From: [REDACTED]
Sent: Monday, March 10, 2025 6:01 PM
To: [REDACTED]
Subject: Re: 遞交 TPB/A/YL-PH/1026 雨水渠務及消防報告

申請編號： TPB/A/YL-PH/1026

申請地點： 新界元朗八鄉橫台山永寧里丈量約份第 111 約地段編號第 2902 號(部份)、2905 號(部份)、2909 號(部份)、2910 號(部份)、2911 號(部份)

致：城市規劃委員會

Drawing number : **b4-1**

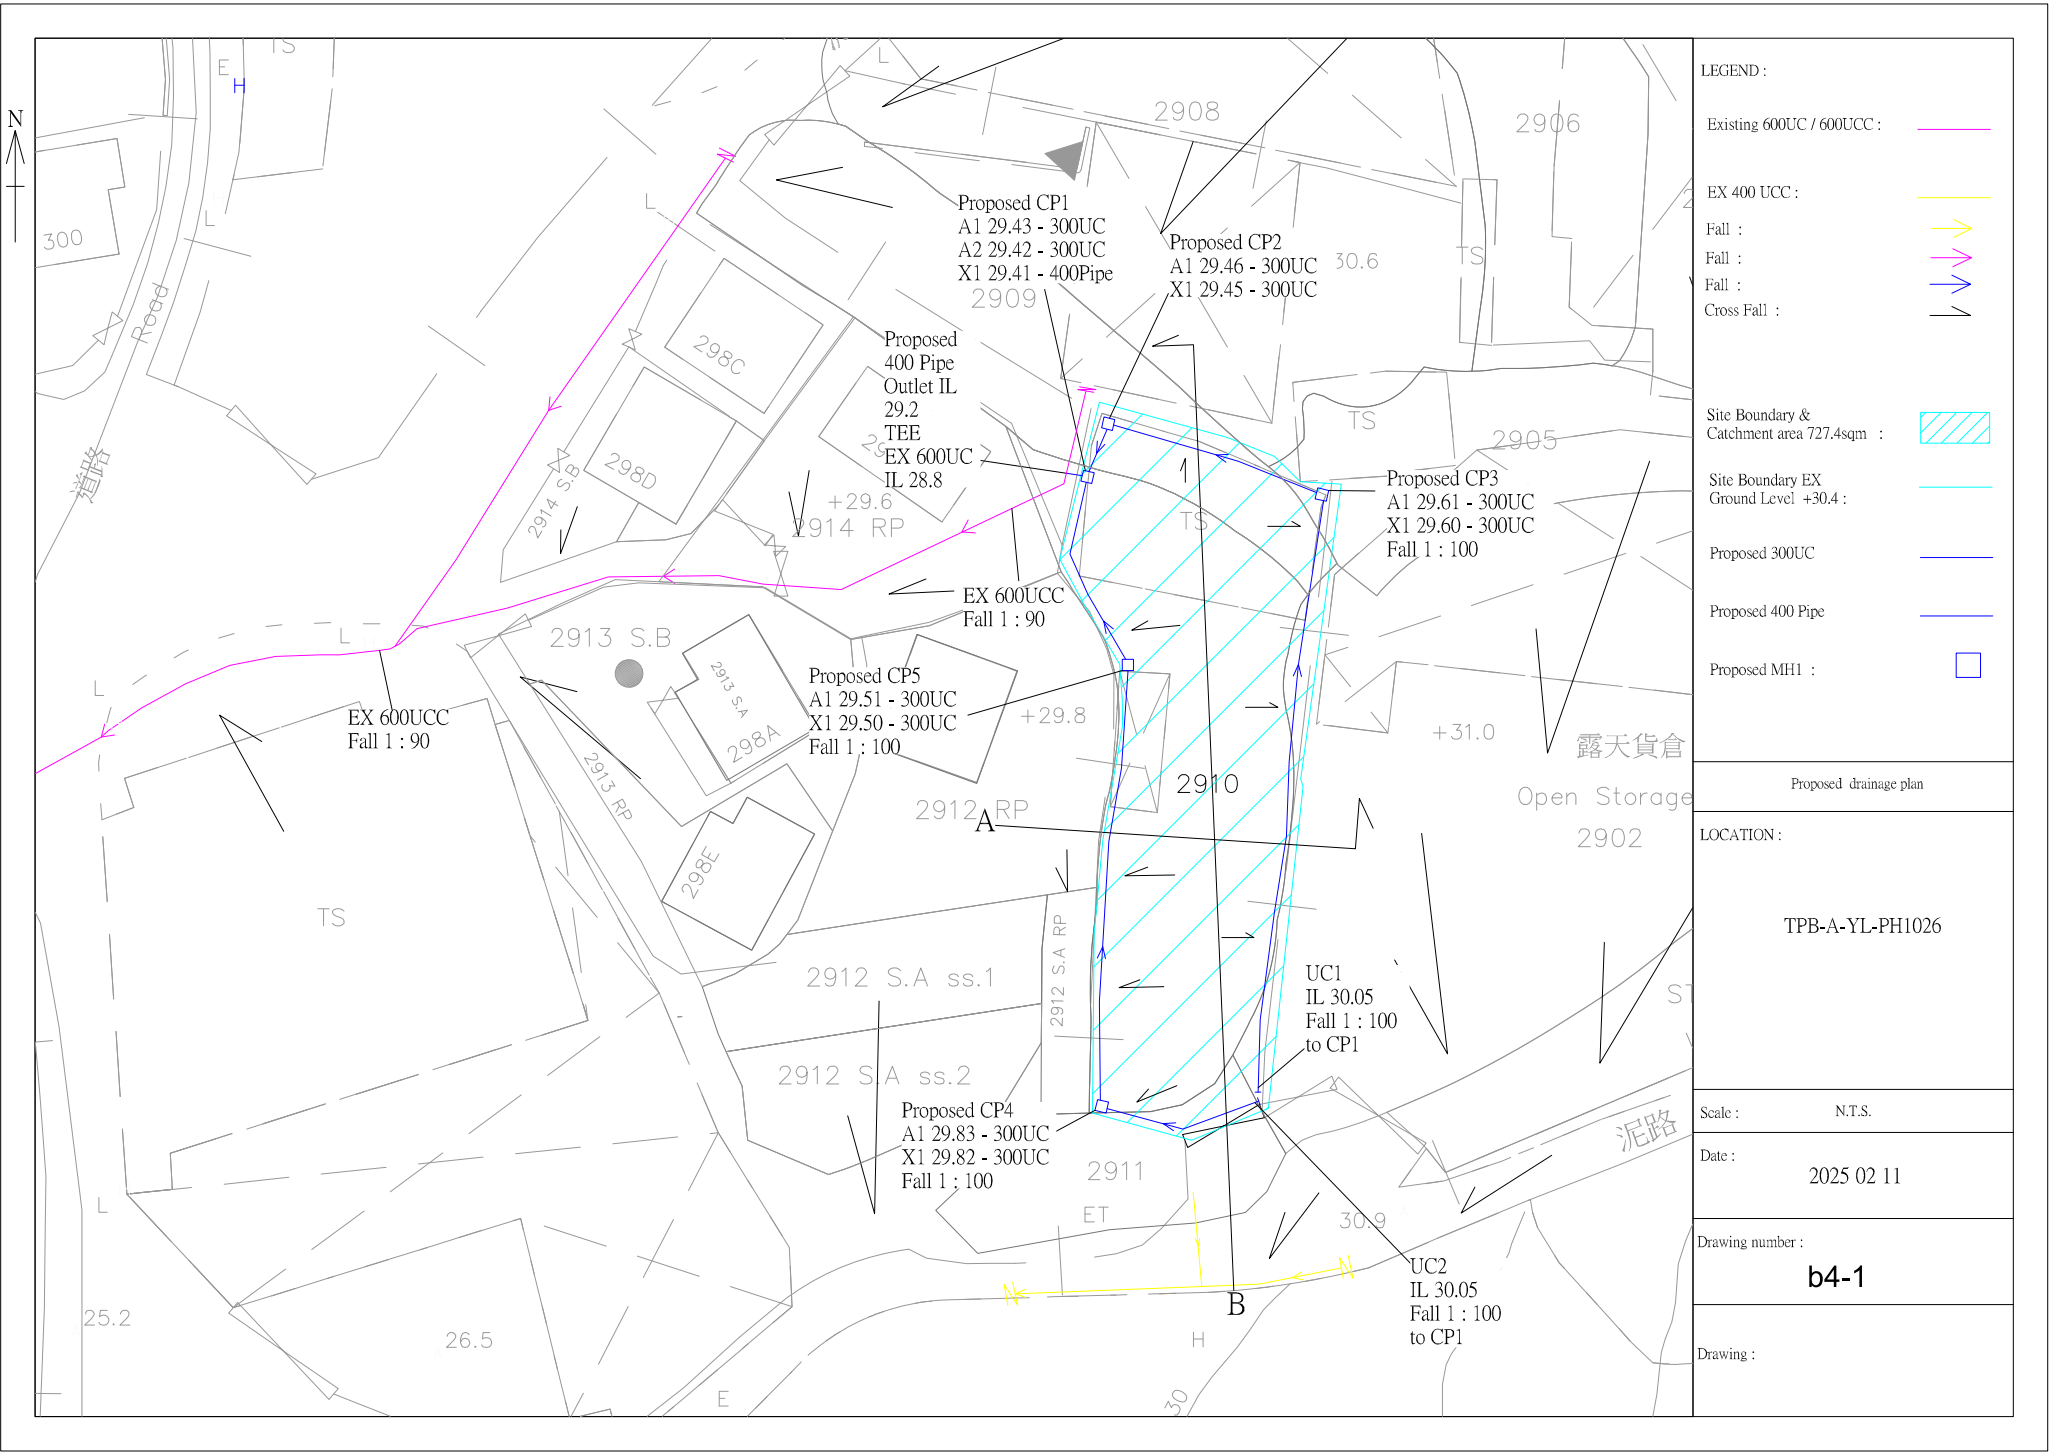
Comments	Answer
(a) Please show calculation details for the reainfall intensity " i " in the submission.	資料在b5-1中示
(b) Catchpit should be provied at the turnong points of the u-channel.	已經加了井, 在b3-1, b4-1. 井細織在b6-1, b8-1中示
(c) The applicant shall resolve any conflict/disagreement with relevant lot owner(s) and seek LandsD's permission for laying new drains/channels and/or modifying/upgrading existing ones in other private lots or on Government land outside the application stie.	知道和明白

路面拍攝位置圖

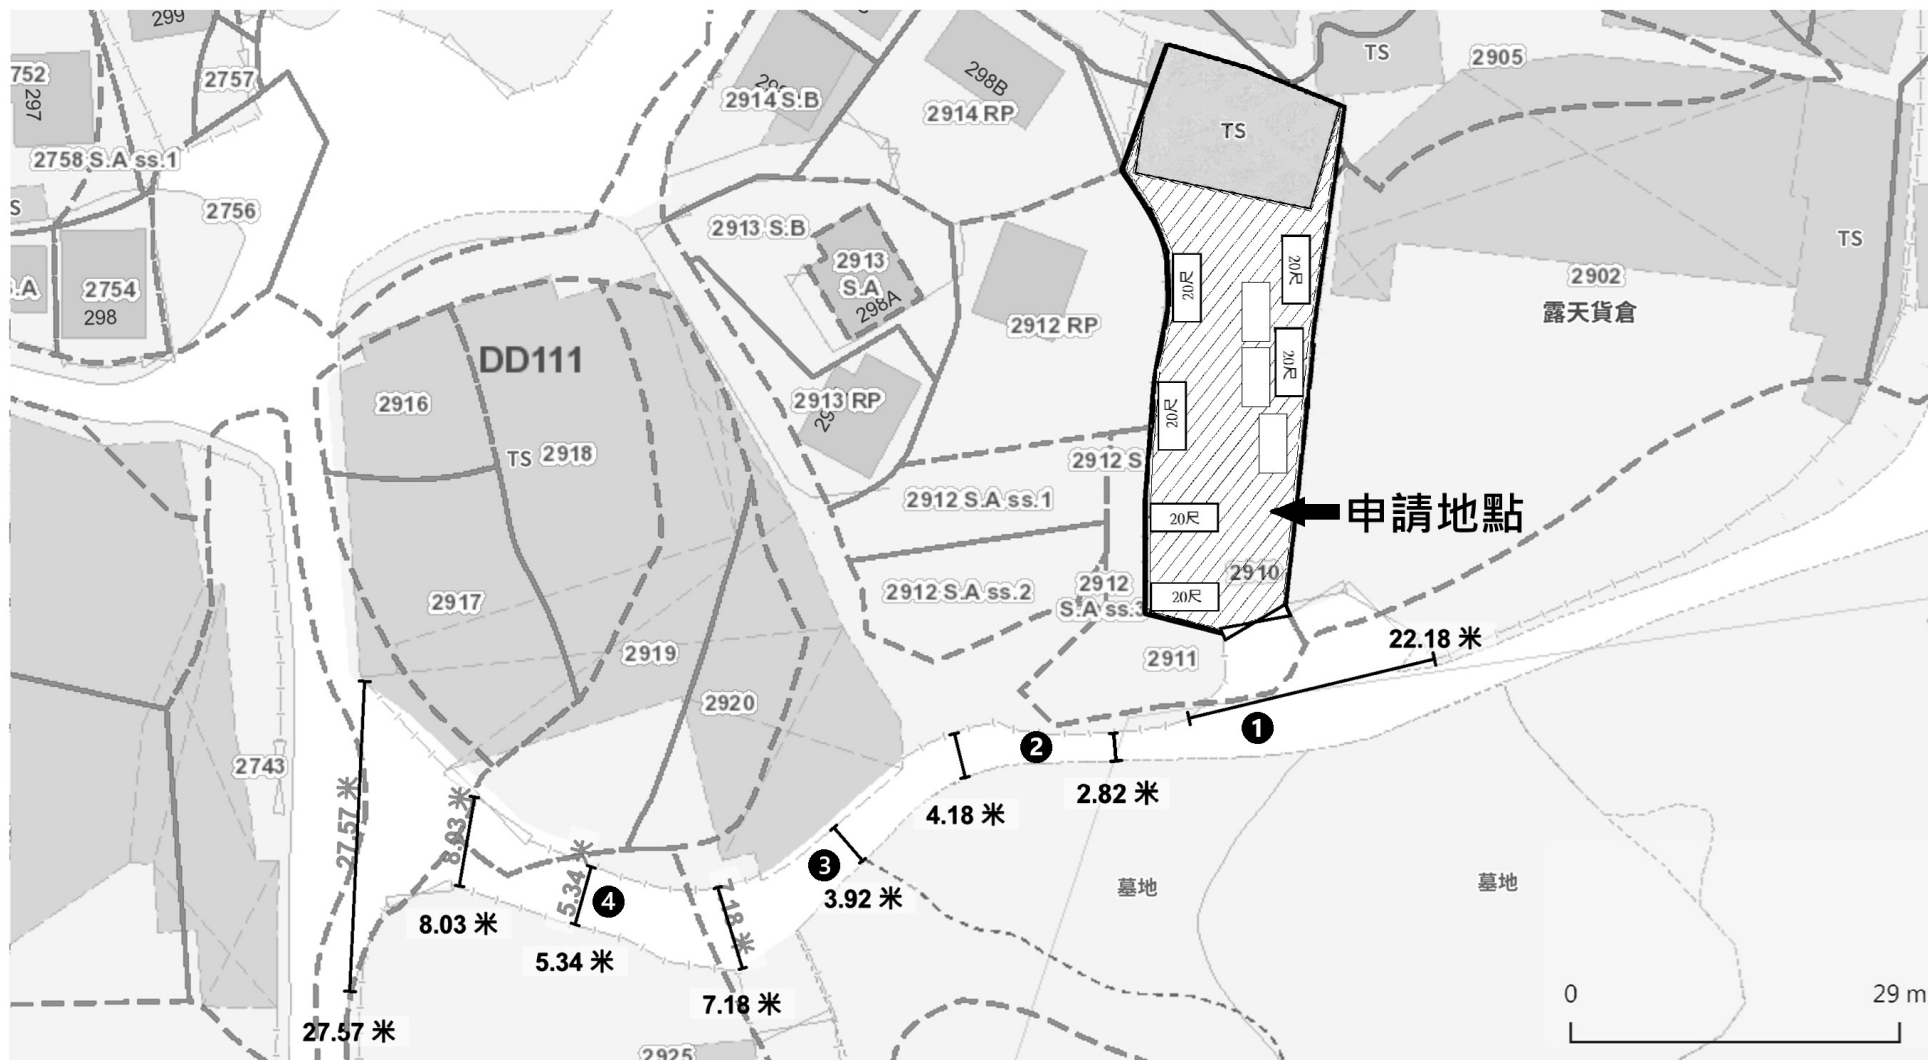
(a) 輕型貨車能在申請場地及鄰近路段順暢行駛，詳情請查閱附件：路面測量結果圖。

有關於 2025 年 2 月 10 日發出的路面測量結果圖，現回應貴署相關意見並附上路面情況的圖片（請參考附件：路面拍攝位置圖），以證明輕型貨車能在申請場地及鄰近路段順暢行駛。
